CHUCK E. CHEESE

City of Aurora Building Division

Project: **Chuck E. Cheese**

Permit: **19-1625136**

Demolition Floor Plan

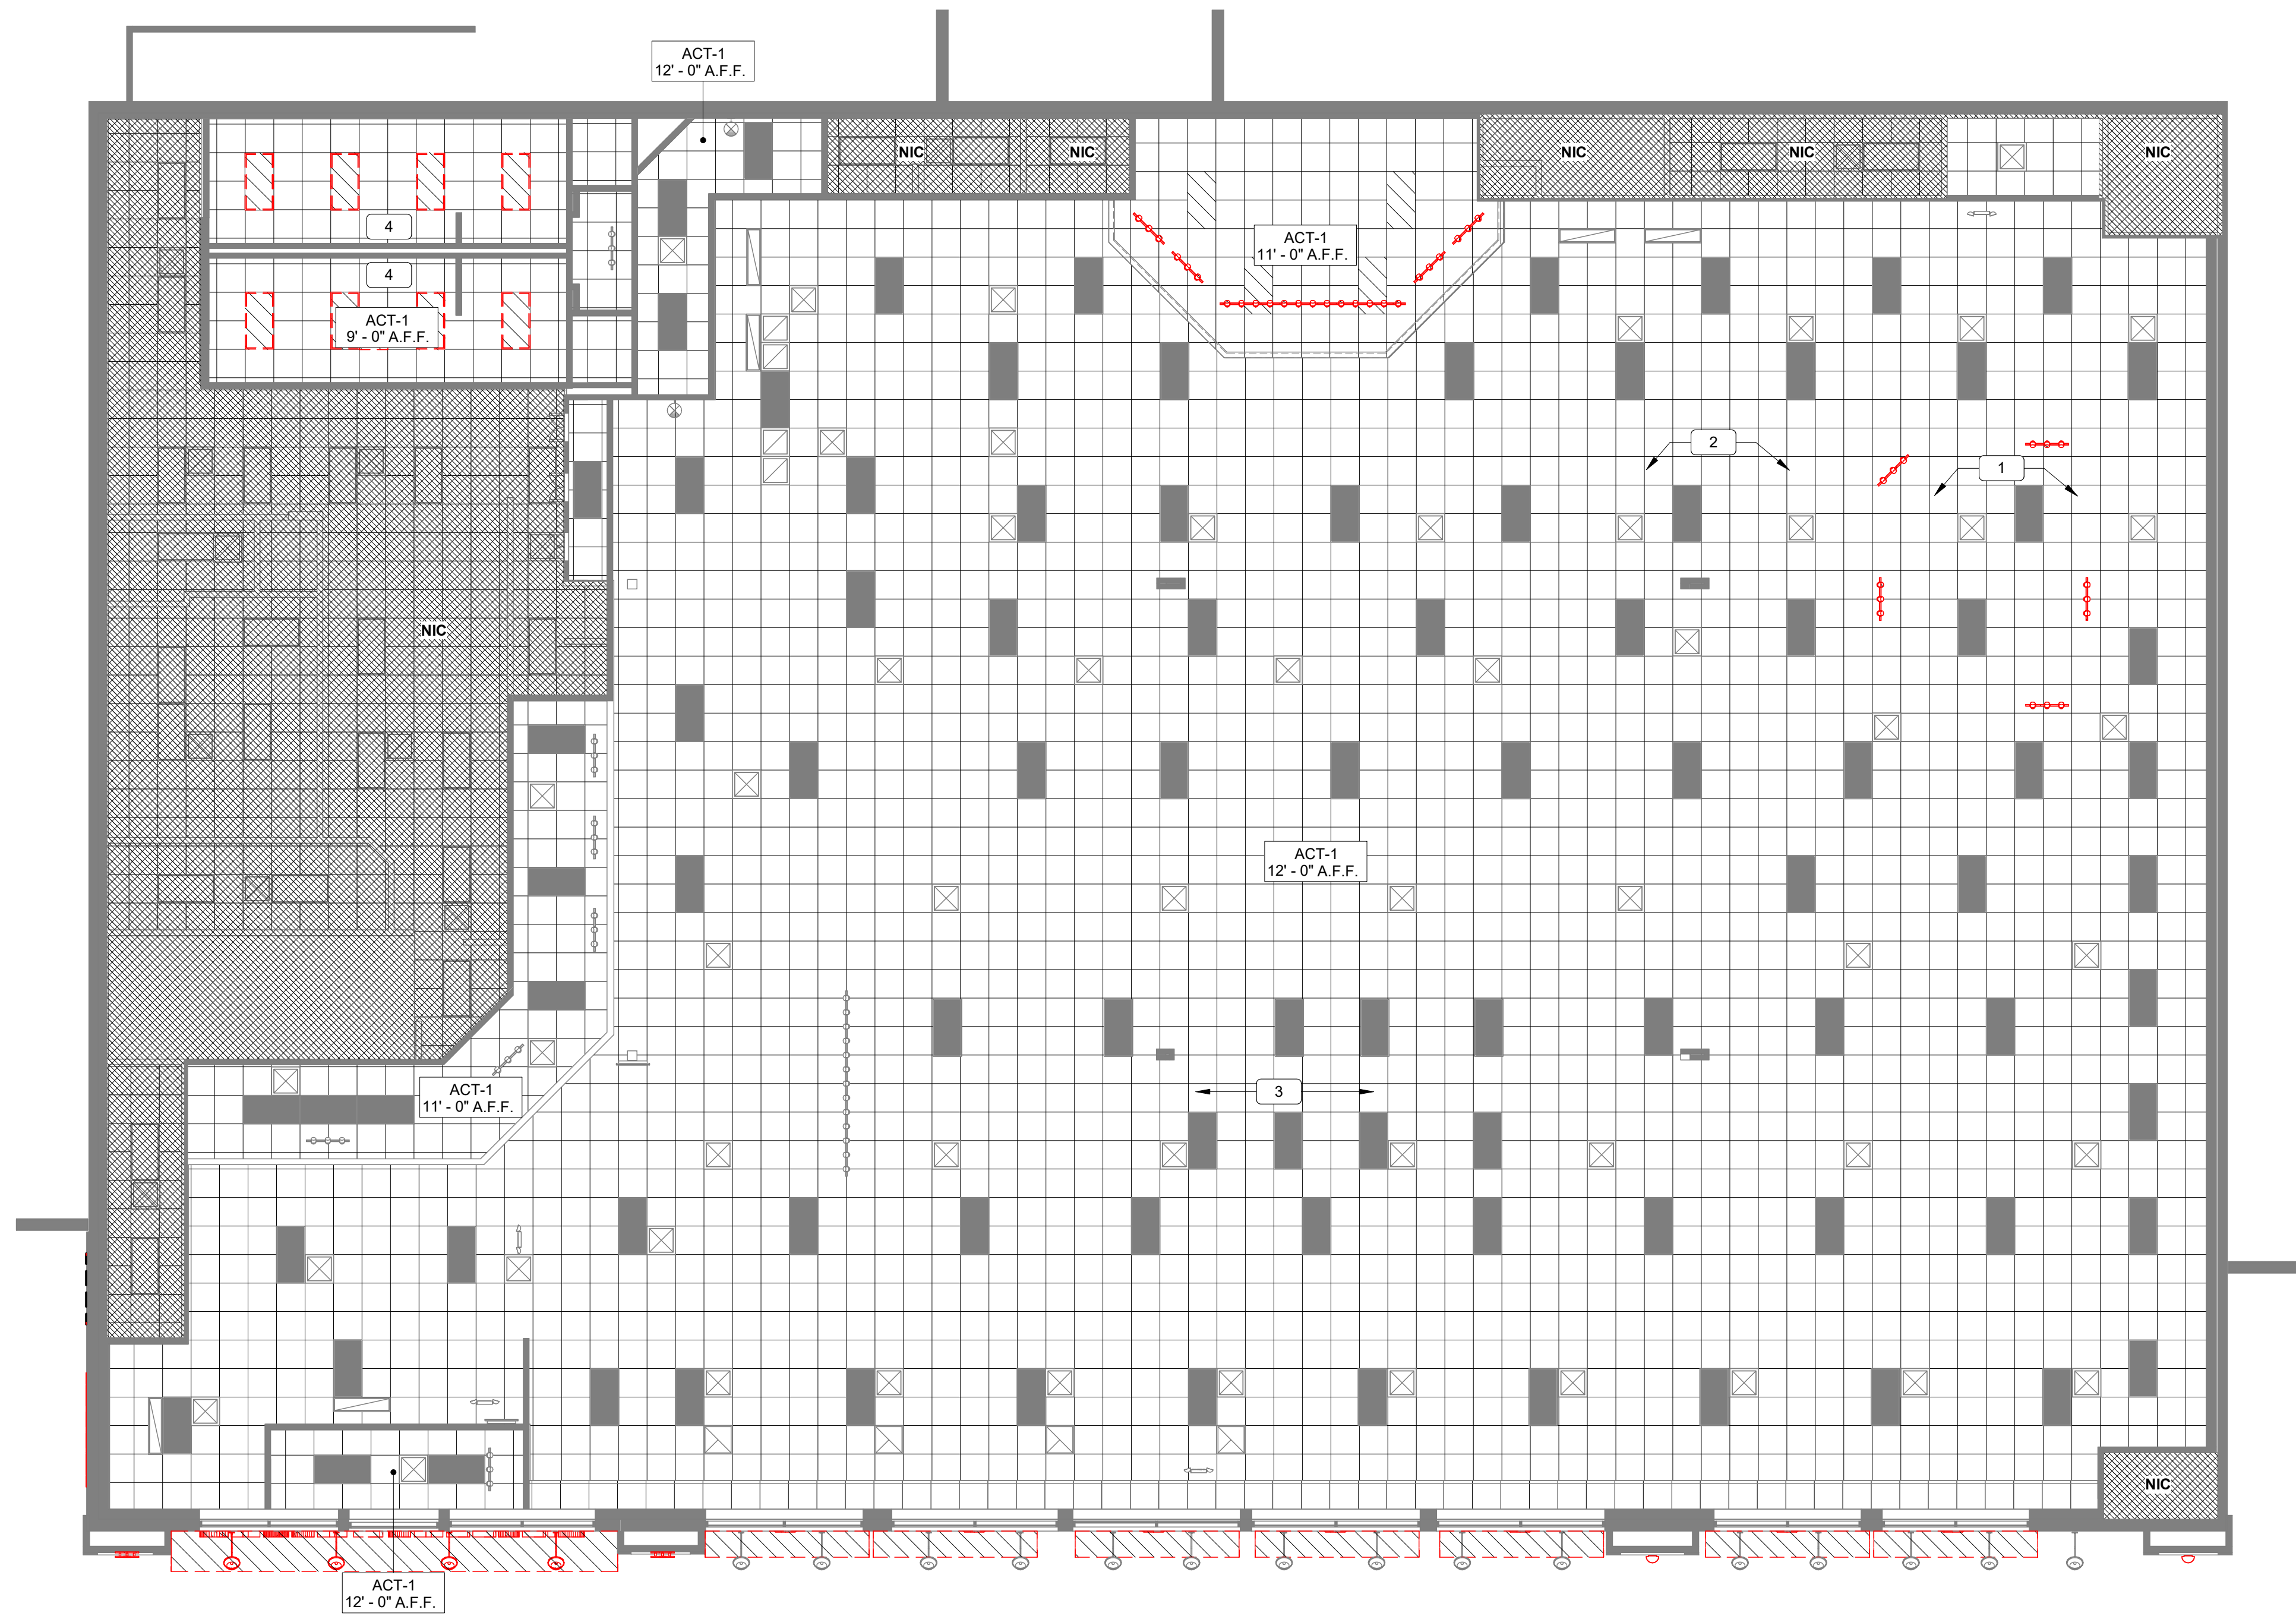
Provide a sign stating "EXIT" in raised, visual characters and braille adjacent to each door in an area of refuge, an exterior area for assisted rescue, an exit stairway or ramp, an exit passageway and the exit discharge.

Floor Plan

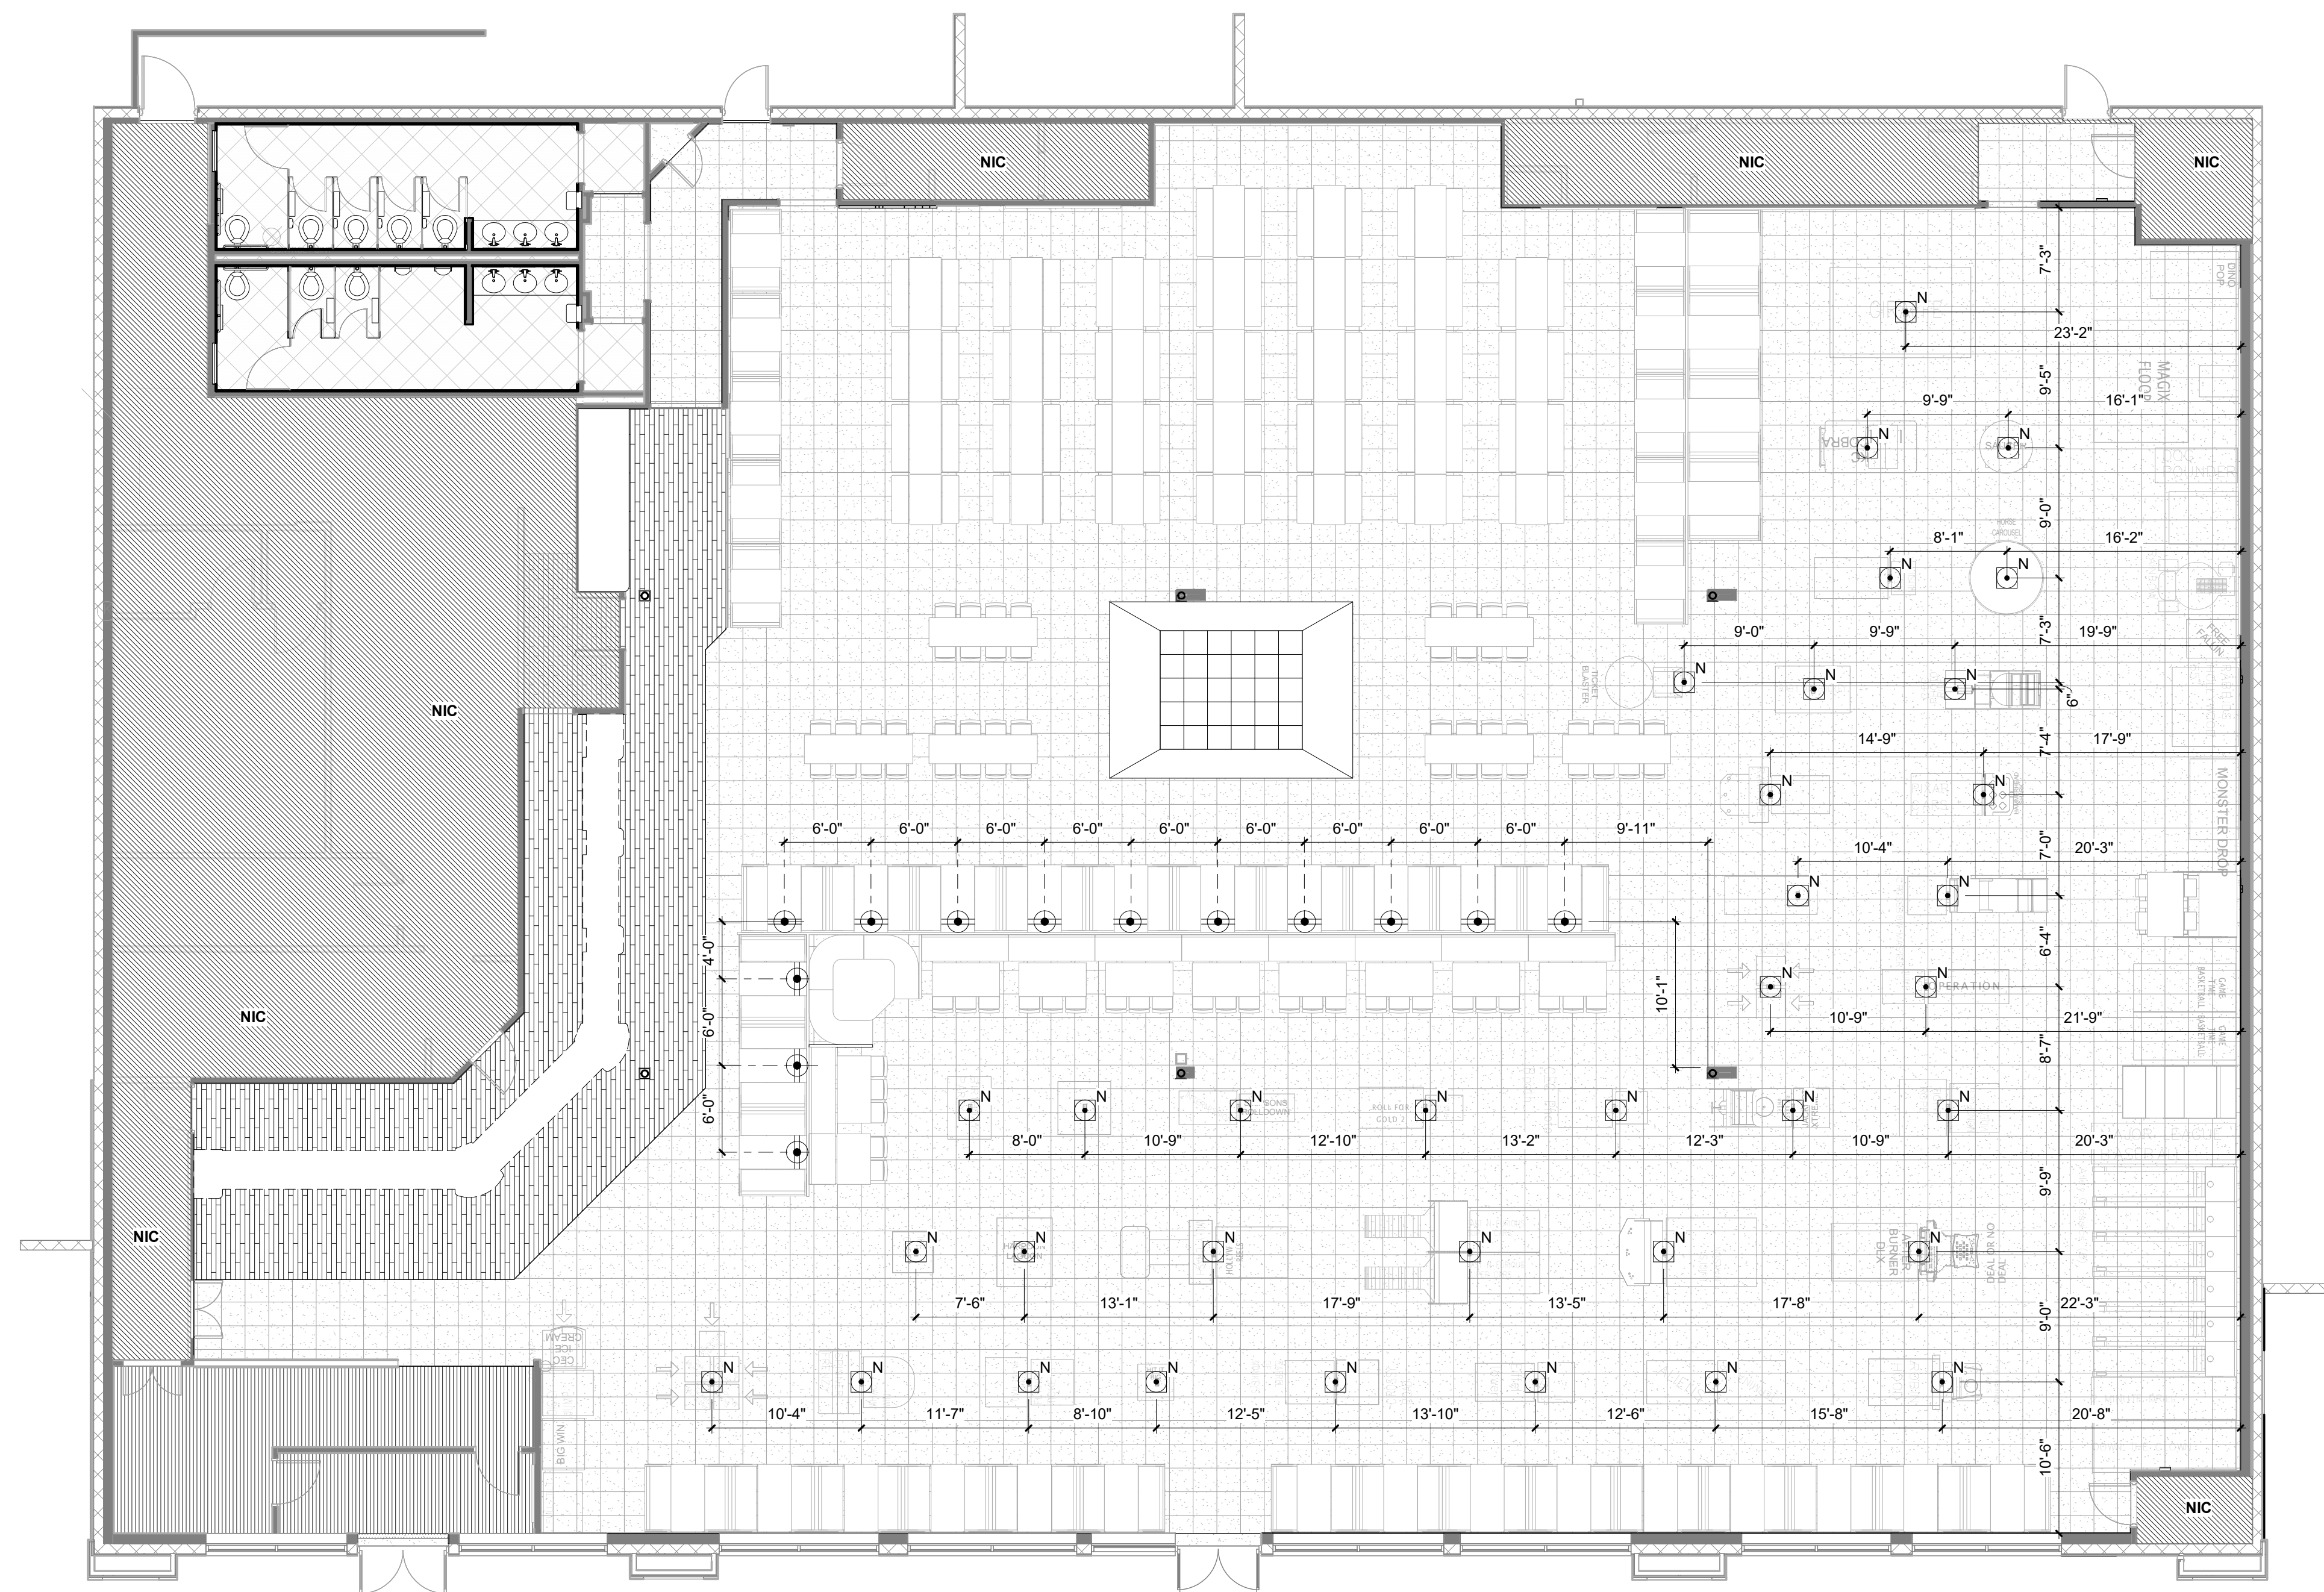
Provide a sign stating "EXIT" in raised, visual characters and braille adjacent to each door in an area of refuge, an exterior area for assisted rescue, an exit stairway or ramp, an exit passageway and the exit discharge.
2015 IBC 1013.4

Reflected Ceiling Plan

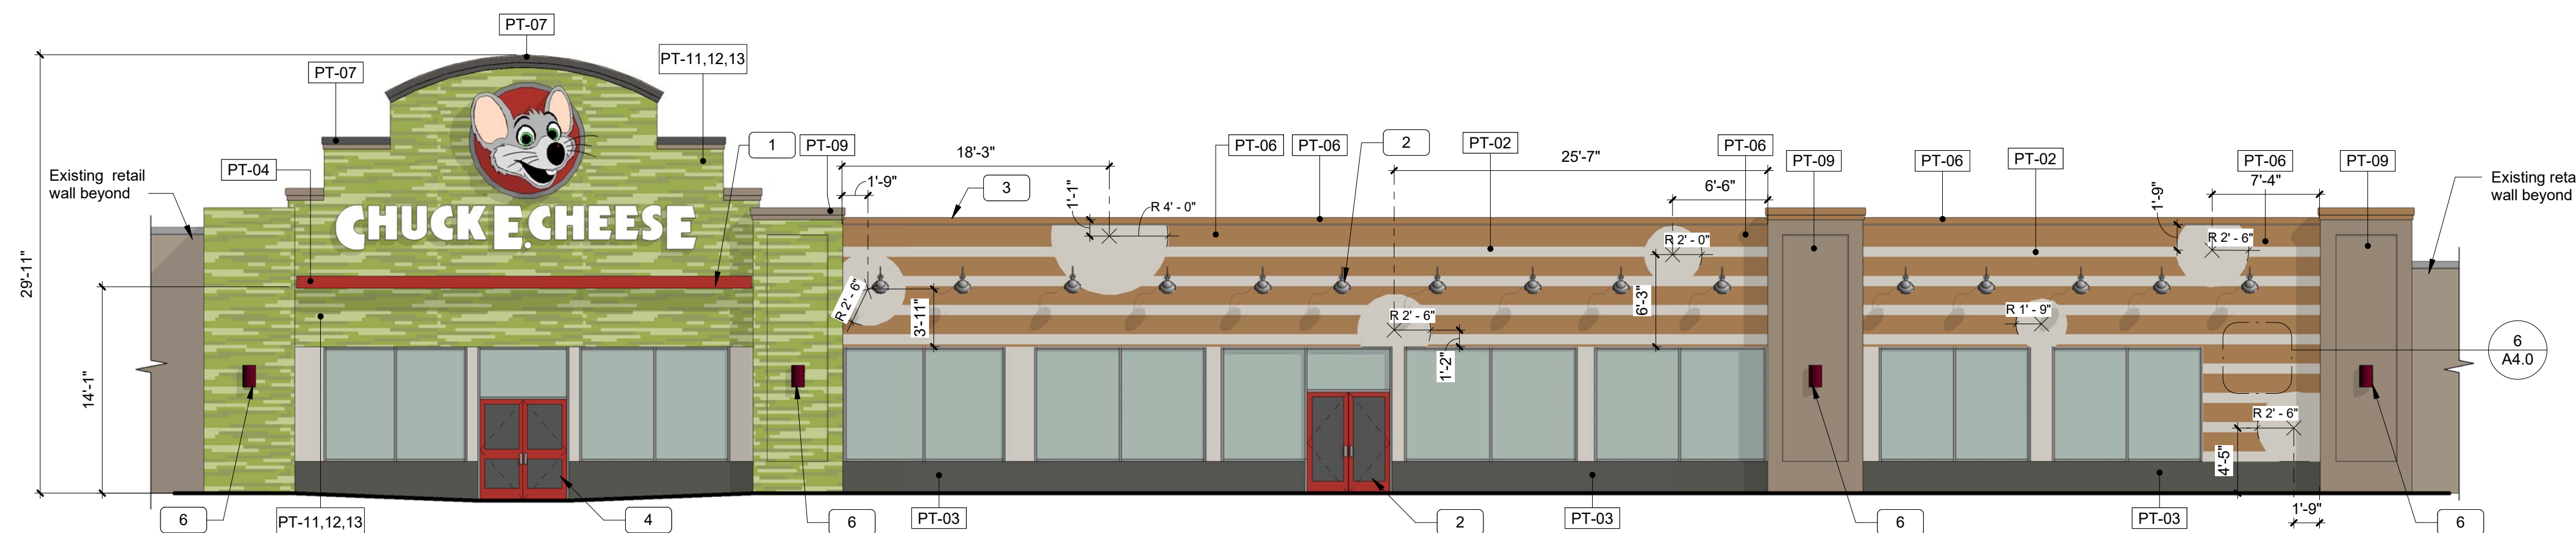
Provide a sign stating "EXIT" in raised, visual characters and braille adjacent to each door in an area of refuge, an exterior area for assisted rescue, an exit stairway or ramp, an exit passageway and the exit discharge.
